ADDENDUM #1 04/01/2024
REVISED SHEETS: TITLE, D11, D12, D14, P1, P2, P4
REVISION #1 06/18/2024
REVISED SHEETS: TITLE, D8A(ADDED), P1-P4, P6, U5, U6, U10, W5, W6
REVISION #2 07/17/2024
REVISED SHEETS: TITLE, D8B(ADDED), D11, P1-P2, P5-P6, W3, MN1-MN2
REVISION #3 07/26/2024
REVISED SHEETS: TITLE, U2-U4, U7, U9, U11-U13, W2-W4, E1-E10
REVISION #4 08/15/2024
REVISED SHEETS: TITLE, D11, D12, P1, P2, U2-U4, U9, U10, U11, PM8, X3, X4
REVISION #5 08/26/2024
REVISED SHEETS: TITLE, U4, U9-U11, W4
REVISION #6 09/10/2024
EVISED SHEETS: TITLE, P5, U4, U8, U9, PM1-PM8

E. WILSON ST. AND E. DOTY ST. RECONSTRUCTION

CITY PROJECT NO. 11543
CONTRACT NO. 8735

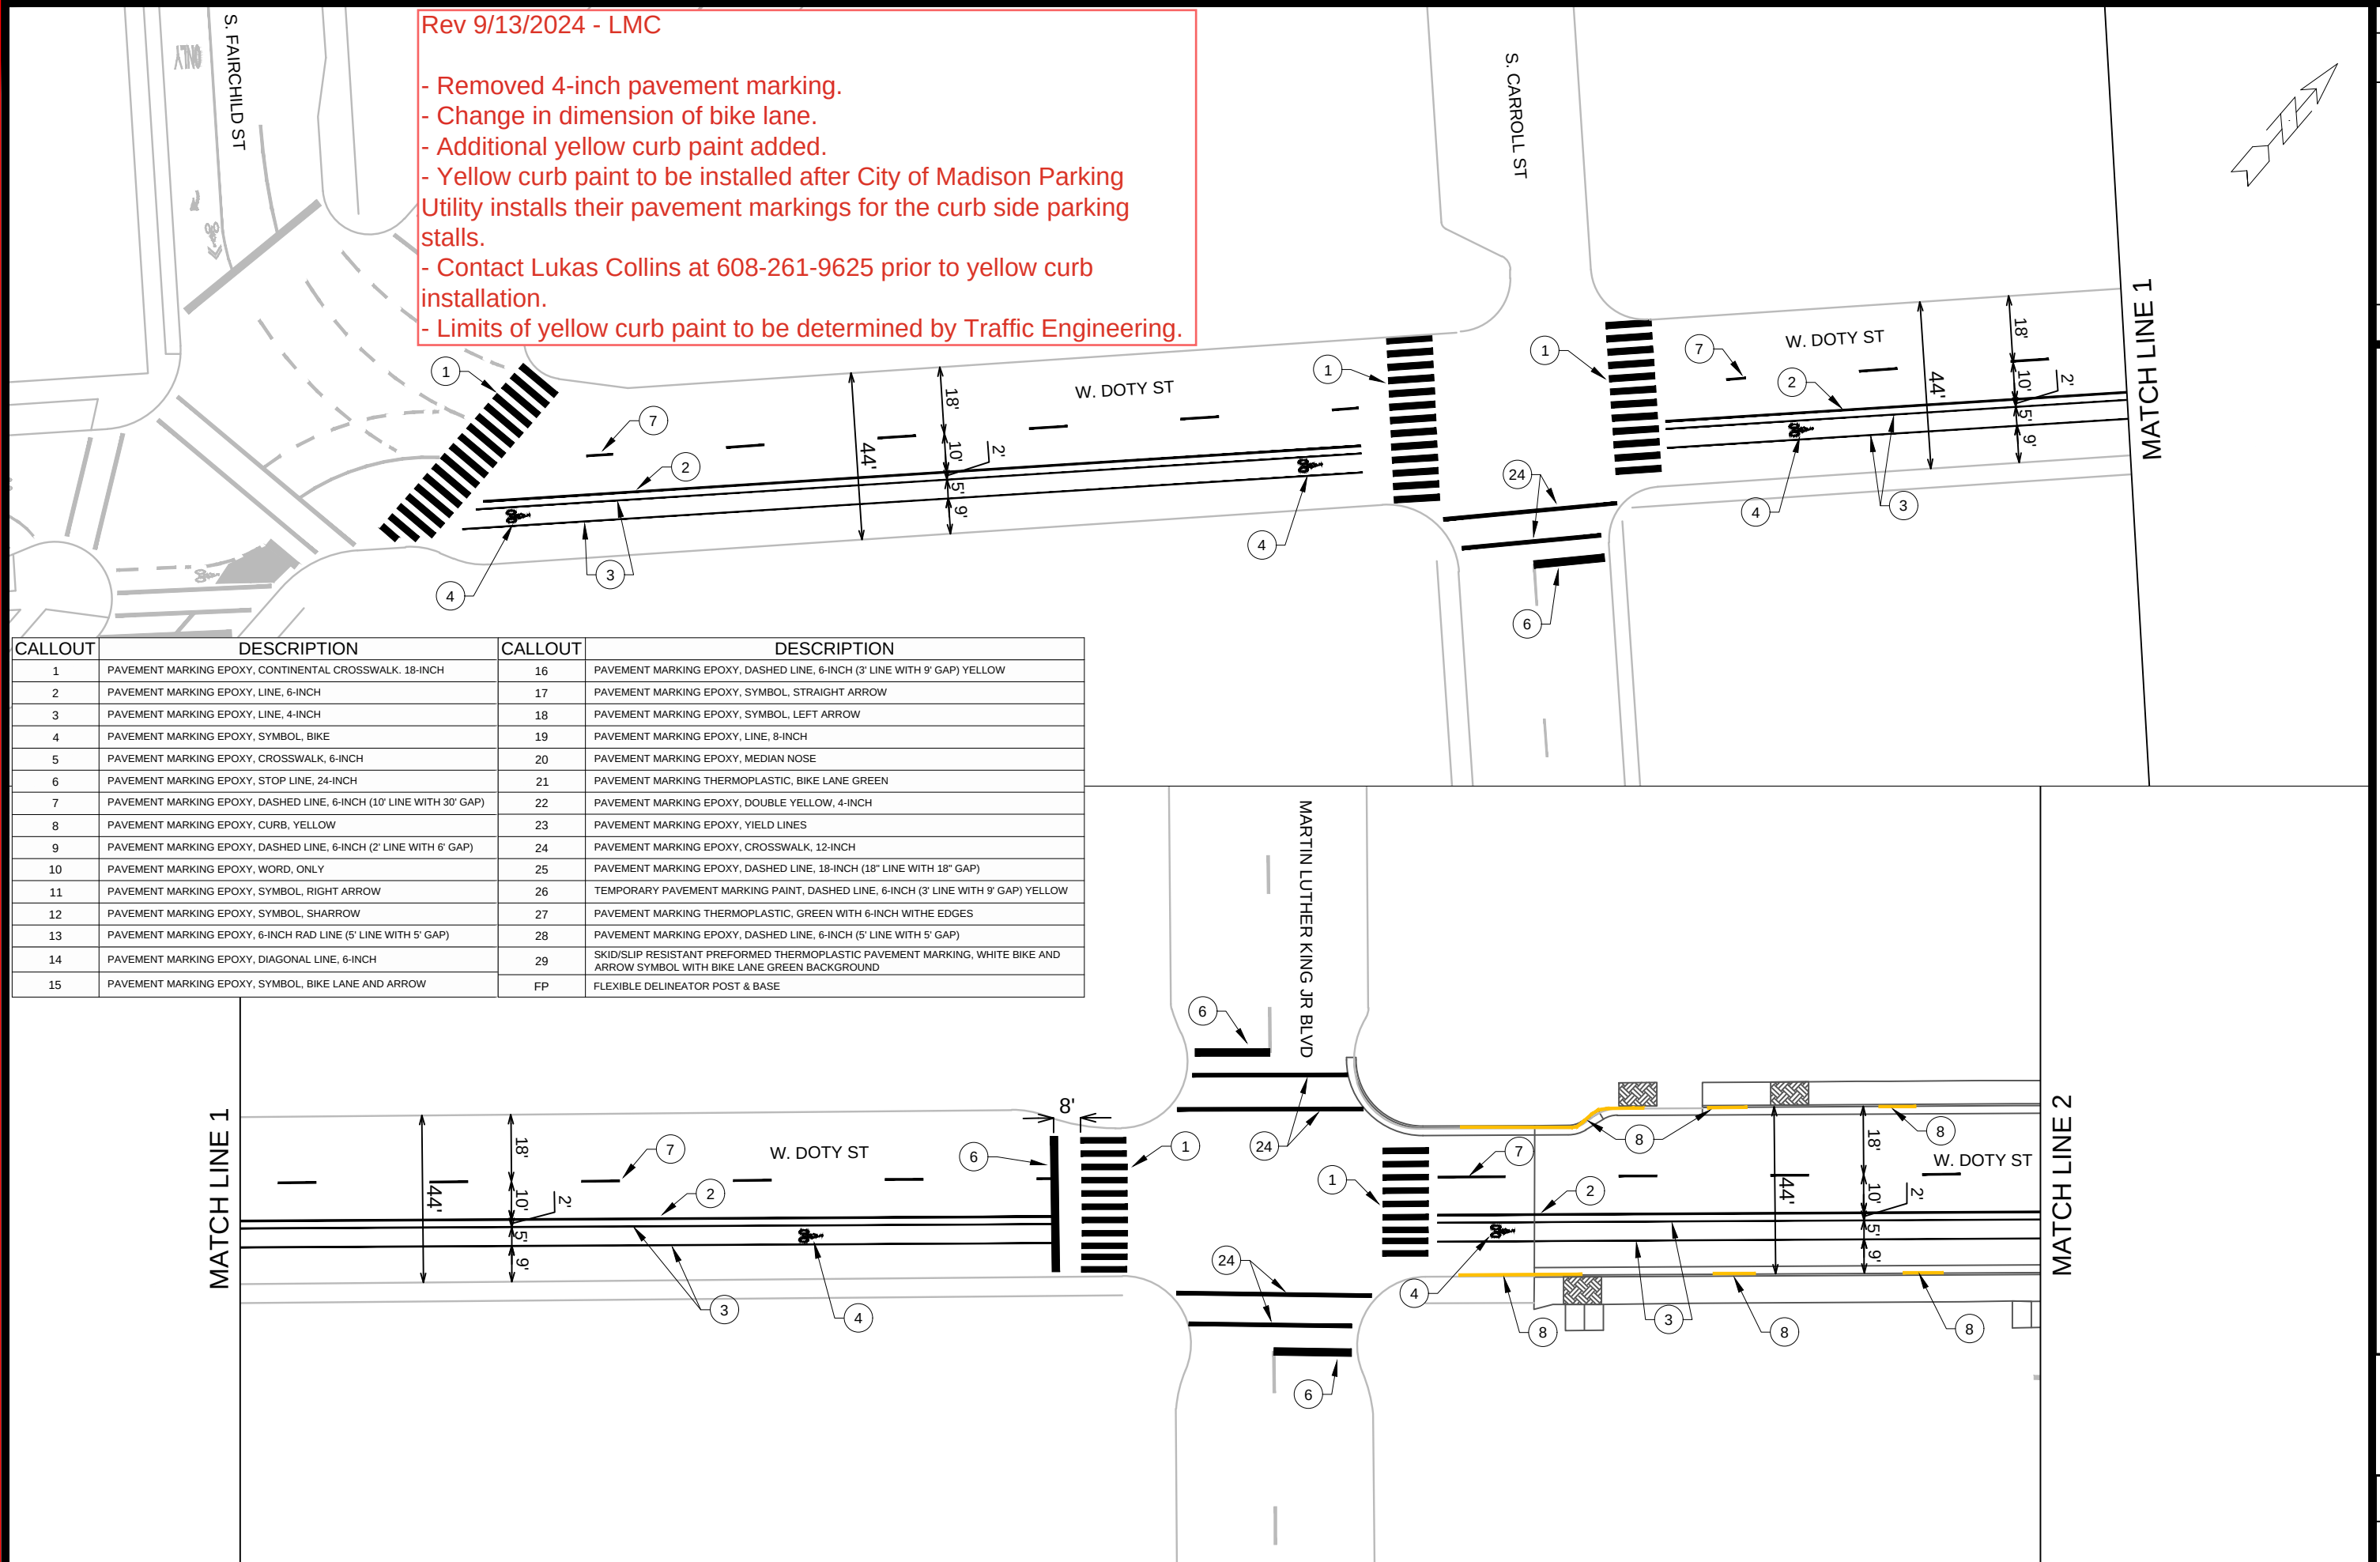
- Removed 4-inch pavement marking.
- Change in dimension of bike lane.
- Additional yellow curb paint added.
- Yellow curb paint to be installed after City of Madison Parking Utility installs their pavement markings for the curb side parking stalls.
- Contact Lukas Collins at 608-261-9625 prior to yellow curb installation.
- Limits of yellow curb paint to be determined by Traffic Engineering.

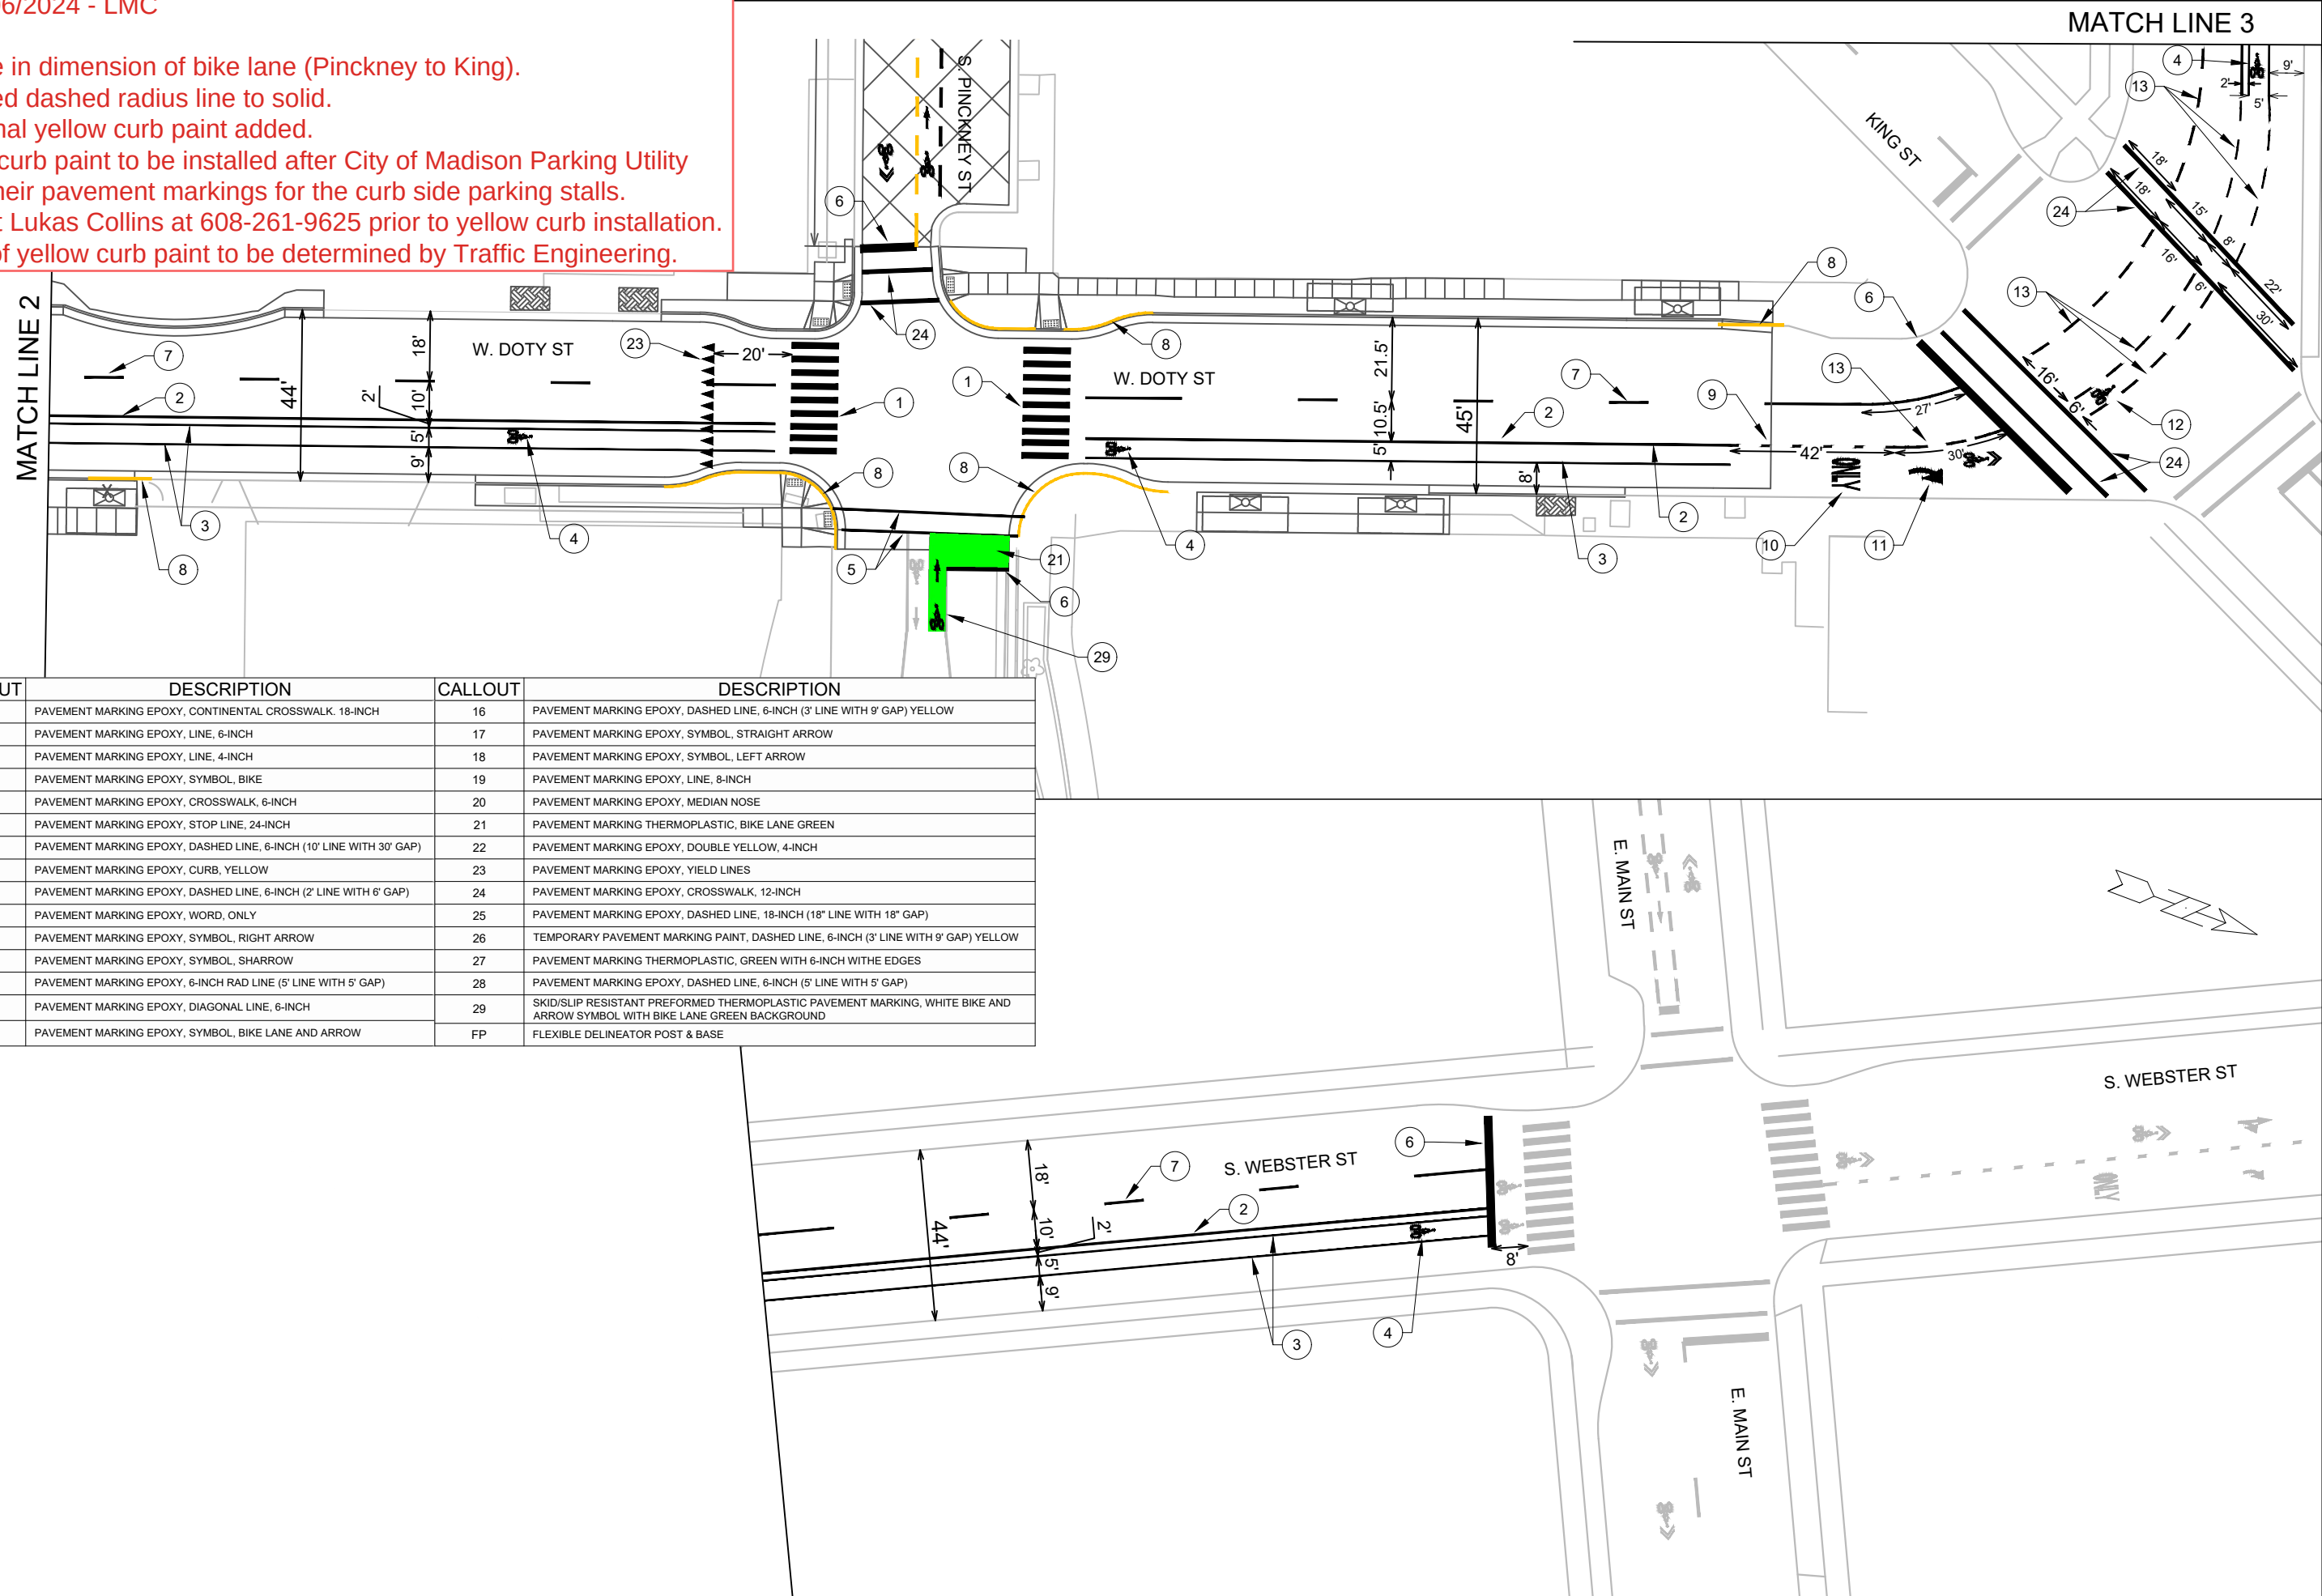
- Change in dimension of bike lane (Pinckney to King).
- Changed dashed radius line to solid.
- Additional yellow curb paint added.
- Yellow curb paint to be installed after City of Madison Parking Utility installs their pavement markings for the curb side parking stalls.
- Contact Lukas Collins at 608-261-9625 prior to yellow curb installation.
- Limits of yellow curb paint to be determined by Traffic Engineering.

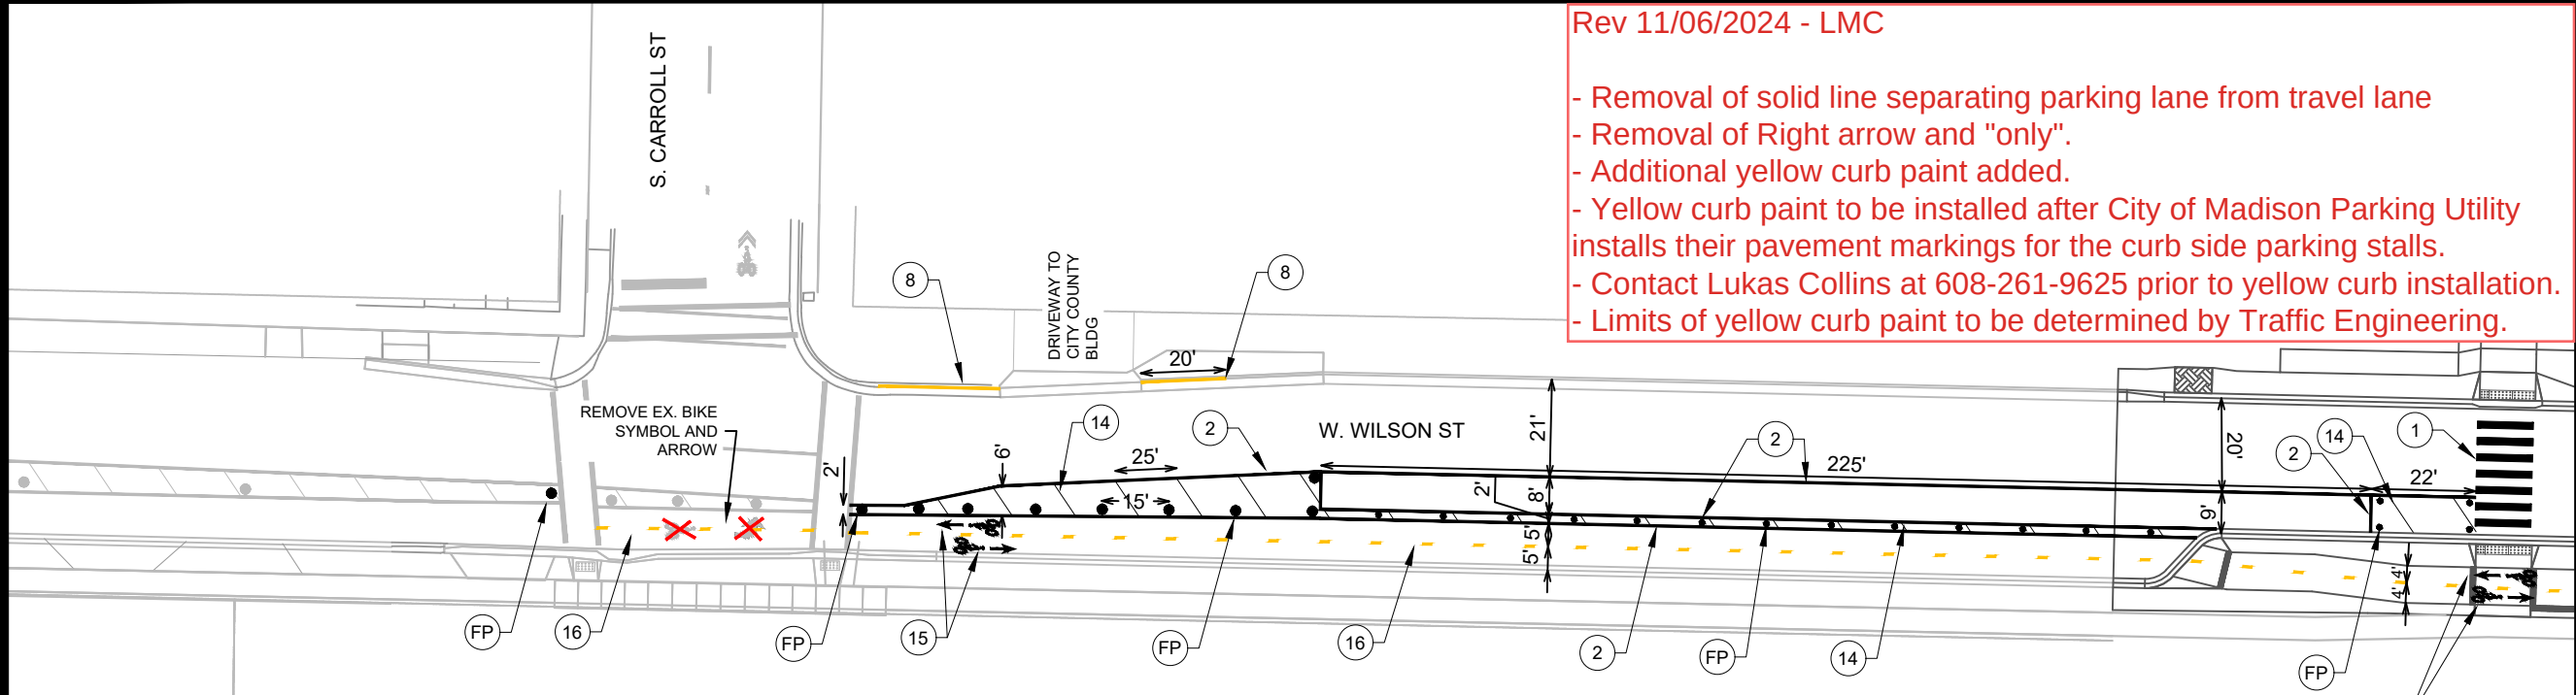
- Removal of solid line separating parking lane from travel lane
- Removal of Right arrow and "only".
- Additional yellow curb paint added.
- Yellow curb paint to be installed after City of Madison Parking Utility installs their pavement markings for the curb side parking stalls.
- Contact Lukas Collins at 608-261-9625 prior to yellow curb installation.
- Limits of yellow curb paint to be determined by Traffic Engineering.
